Access Compliance Report Public Rights-of-Way (Curb Ramps)

Main Street: RANCHO_SANTIAGO_BLVD Cross Street: SPRING_ST Location: SW

ADA ID: RPAT210928091450 Ramp Type: Type 4 - Parallel Initial Pass/Fail: Fail Overall Compliance: No Severity Score: 20

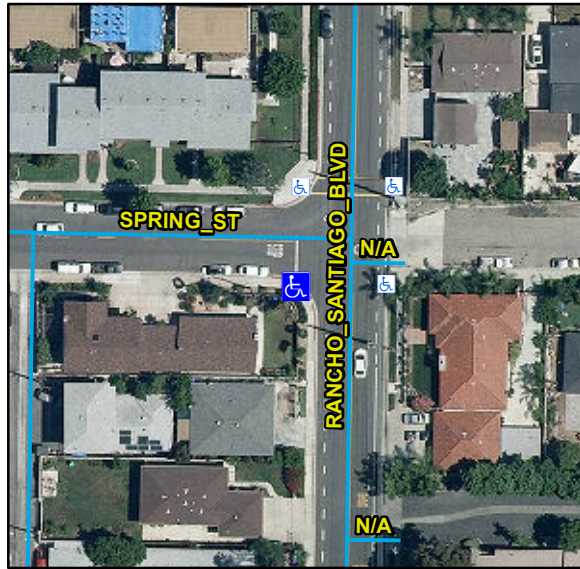
Compliance	Description	Data	Compliance	Description	Data
N/A	Ramp Length LT (in)	108	N/A	Ramp Length RT (in)	104
No	Ramp Width LT (in)	47	No	Ramp Width RT (in)	47
No	Ramp Run Slope LT (%)	10.1	Yes	Ramp Run Slope RT (%)	1
Yes	Ramp Cross Slope LT (%)	0	No	Ramp Cross Slope RT (%)	3.1
N/A	Landing Present	N/A	N/A	DWS Provided	N/A
N/A	Landing Length (in)	N/A	N/A	DWS Contrast	N/A
N/A	Landing Width (in)	N/A	N/A	DWS Length (in)	N/A
N/A	Landing Run Slope (%)	N/A	N/A	DWS Full Width	N/A
N/A	Landing Cross Slope (%)	N/A		DWS Offset Type	N/A
N/A	Landing Movement Obstructed?	N/A	N/A	DWS Offset Left (in)	N/A
	Landing Movement Type	N/A	N/A	DWS Offset Right (in)	N/A
N/A	Landing Shared	N/A			
N/A	Clear Space	Yes			
N/A	Clear Space To Crosswalk (in)	N/A			
N/A	Marked Crosswalk 1	No	N/A	Marked Crosswalk 2	No
	Crossing 1 Direction	E		Crossing 2 Direction	N
	Marked Crosswalk 1 Width (in)	N/A		Marked Crosswalk 2 Width (in)	N/A
N/A	Ramp Inside Crosswalk 1	N/A	N/A	Ramp Inside Crosswalk 2	N/A

Remove & Replace Curb Ramp With Two New Directional Ramps or Equivalent.

R304.5.1, R304.3.2, R304.5.3, STD 1115
